Application Number SSD-97528708

Proposal Mixed used development with in-fill affordable housing

Location 13 Gipps Street, 6 Shadforth Street and 142-148, 160 Oxford Street, Paddington

Figure 1: 3D visuals of the existing (left) and proposed (right) built form viewed from the north east
Source: Sun eye views by Smart Design Studios

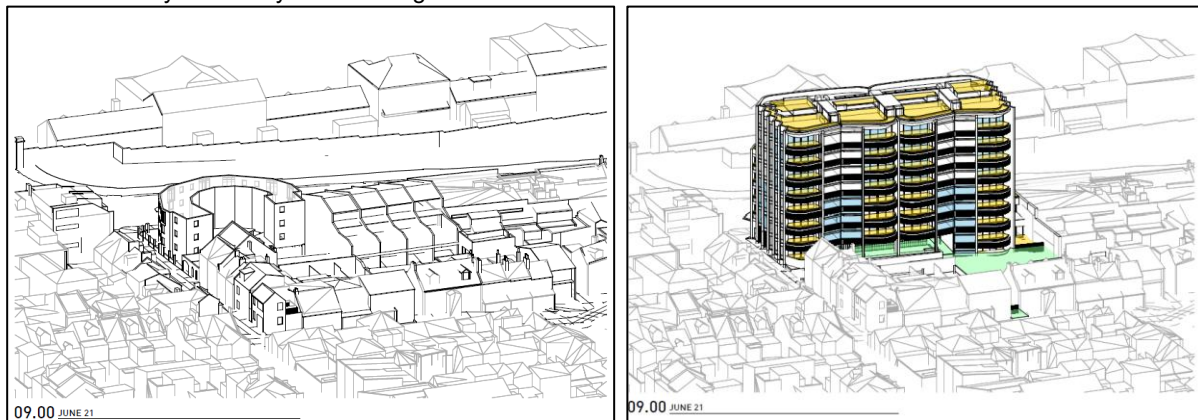
It is clear from the 3D images of the existing context and proposal below (Figure 1) that the proposed 8-9 storey form is not visually consistent with the character of the lower density residential zone and fails to reflect the key desired character attributes of the Paddington Heritage Conservation Area, which includes a low scale cohesive character.

Given that the adjoining R2 zone permits a maximum height of 3 storeys under the LMR provisions it is not agreed that the proposal is contextually appropriate at the zone interface, particularly as the impact will not diminish over time given the heritage significance of the Paddington HCA.

Figure 5: Views from the site
Source: Architectural Design Report Smart Design Studio

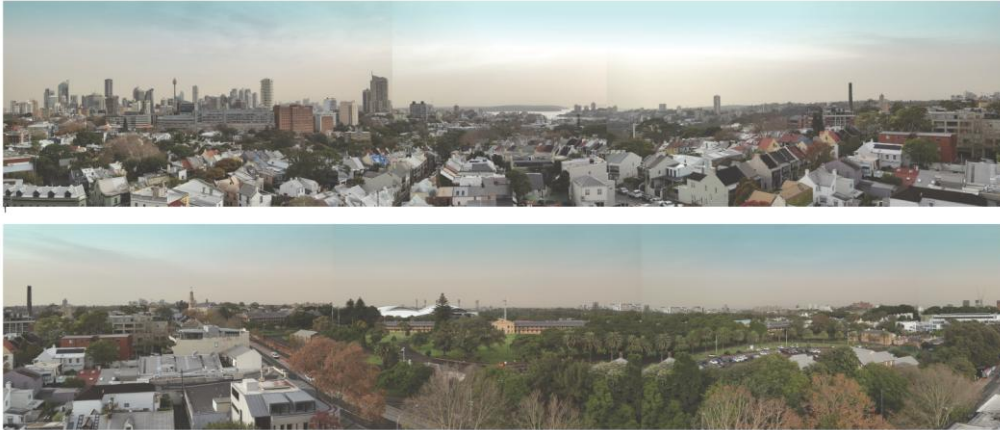
- The 8-9-storey building would result in an overbearing impact to the low scale surrounding properties and result in a loss of privacy due to the significant non-compliance with the ADG separation requirements.
- The Architectural Design Report identifies that the site benefits from extensive views to both the City, Harbour and eastern suburbs and also the SCG, Victoria Barracks and Moore Park. Refer to the extract from the design report at Figure 5.

Figure 7: L1 plan which shows the fully enclosed corridors in yellow
Source: Architectural Drawing Smart Design Studio. Yellow highlight Council staff.

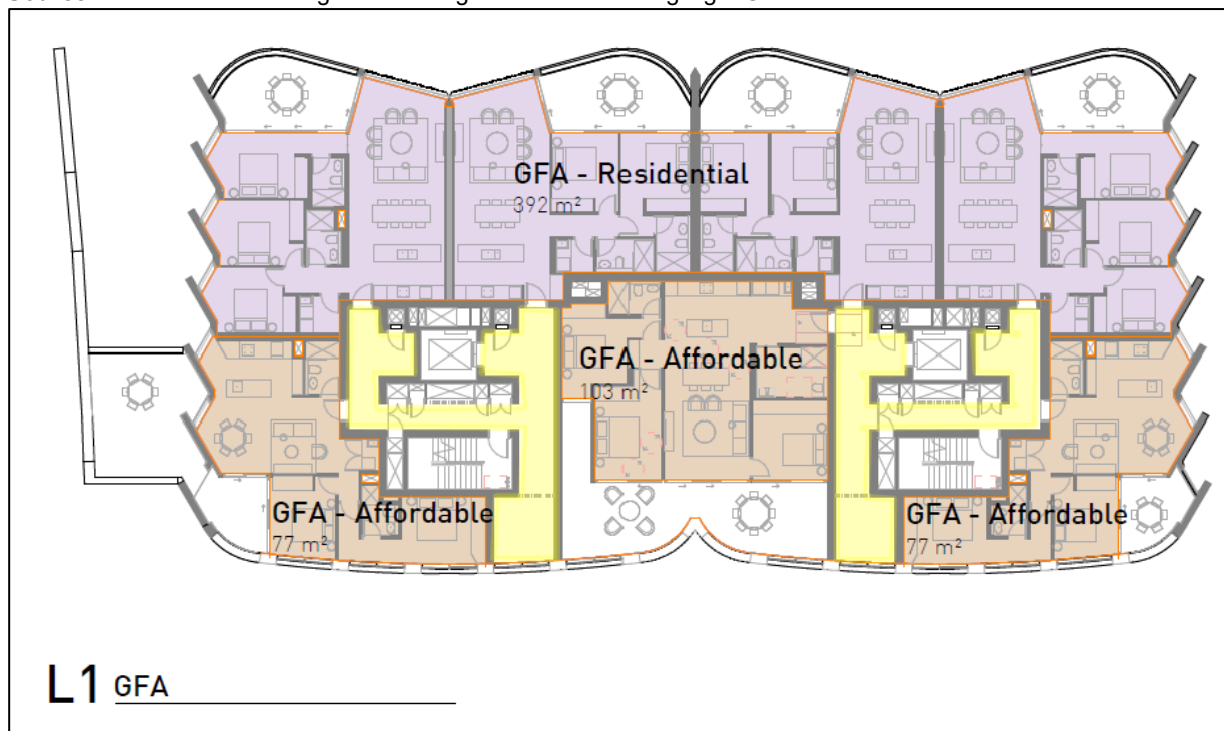
Whilst the proposal is stated to comply with the 2.86:1 FSR permitted under the LMR and in-fill affordable housing provisions in the Housing SEPP, the FSR is incorrectly calculated. Specifically, the internal corridors at levels LG, L0, L1, L2, and L3 of the building have not been included in the GFA calculations. It appears that the corridors have been excluded on the basis that they incorporate louvre doors to the communal pool area at levels LG and L0, and louvres to the southern elevation at levels L1, L2, and L3.

This interpretation is contrary to that made by Commissioner Morris in *Landmark Group Australia Pty Ltd v Sutherland Shire Council [2016] NSWLEC 1577* which concluded the corridors within the internal face of the external walls of the building should be included as GFA. Furthermore, the louvres to the corridors at levels L1, L2, and L3 to the south are fully enclosed by the fixed external glazing to the southern façade and the floor levels above and below. Refer to Figure 7 an extract of the L1 plan which shows (in yellow) the fully enclosed corridors which should be calculated as GFA.

The GFA of the corridors significantly adds to the bulk and scale of the building resulting in a non-compliance with the FSR standard and objectives.

Figure 8: Annotated section showing number of storeys
Source: Section D Smart Design Studio. Annotations Council Staff

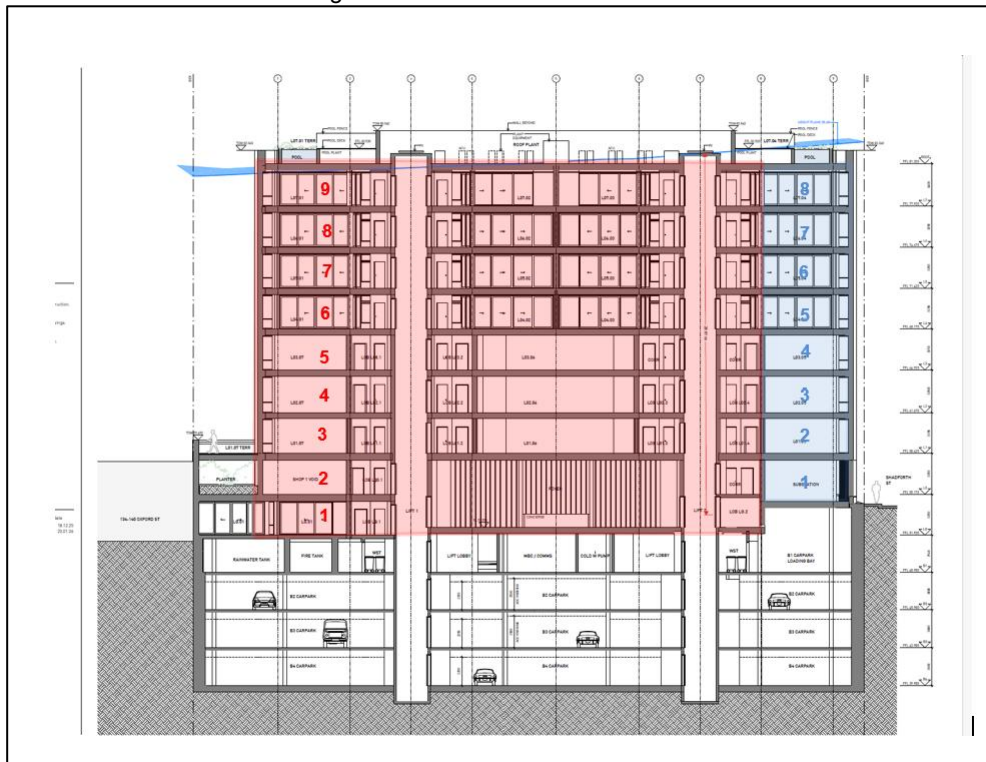
The EIS incorrectly describes the proposal as 8-storeys in height. The proposal comprises of 9 levels (LG, L0, L1, L2, L3, L4, L5, L6, and L7) and includes double height voids to the retail spaces, lobby and a section of parking level B1.

The provided sections fail to depict the existing ground level, but it appears the only section of the LG level located below ground is the void to parking level B1. This results in the building predominantly comprising of 9-storeys. This is indicated in the annotated section at Figure 8, which depicts the approximate 9-storey section of the building in red and the 8-storey section of the building in blue.

Figure 15: View from the sun 10am
Source: Architectural Design Report

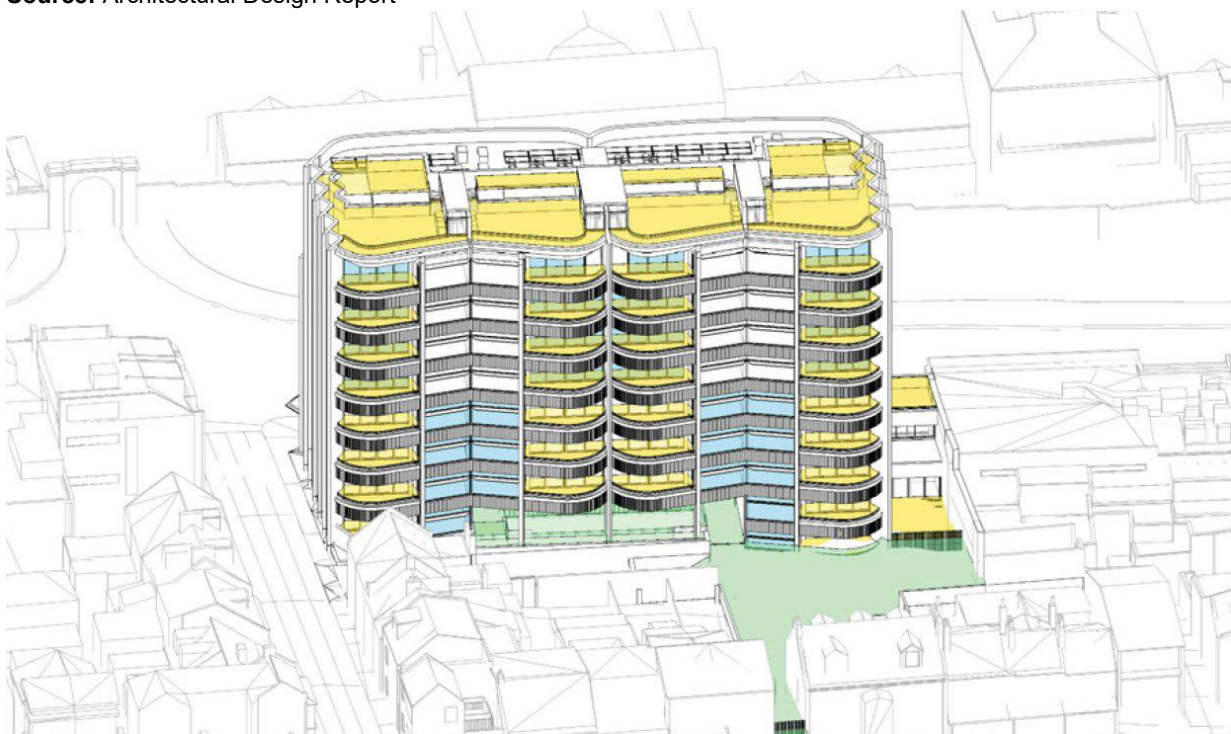
Unfortunately, the cross sections in the drawings do not demonstrate the scale relationship to the residential properties to the north. The east elevation does provide some indication of the disparity in scale. The views from the sun in architectural Drawing 851 B demonstrate the significant difference of the bulk and scale of the proposed development to its surroundings (see Figure 15).

The height, bulk, scale and character of the proposed development is a poor response to the heritage significance and character of the conservation area.

Figure 18: extract from DA101 B - Level 0

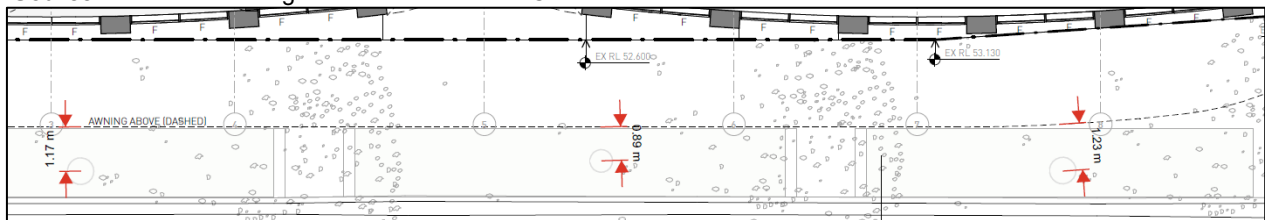
The arborist report includes a pruning specification for trees 2, 3, 4 & 5 identifying branches to be removed to allow for scaffold erection.

- To protect the street trees No's 2, 3 & 4, the plans must show the street awning along Oxford St to allow for a minimum 1.5m offset from the centre of trunk of each tree.
- The balcony to the apartment located on the LG level is at a slightly lower level than the adjoining communal open space which results in the balcony being directly overlooked. This should be addressed.
- To reduce excavation, minimise potential hydrogeological hazards, and support sustainable transport outcomes, a maximum of 43 car parking spaces should be provided. 2 of the 43 spaces should be allocated for car share use.
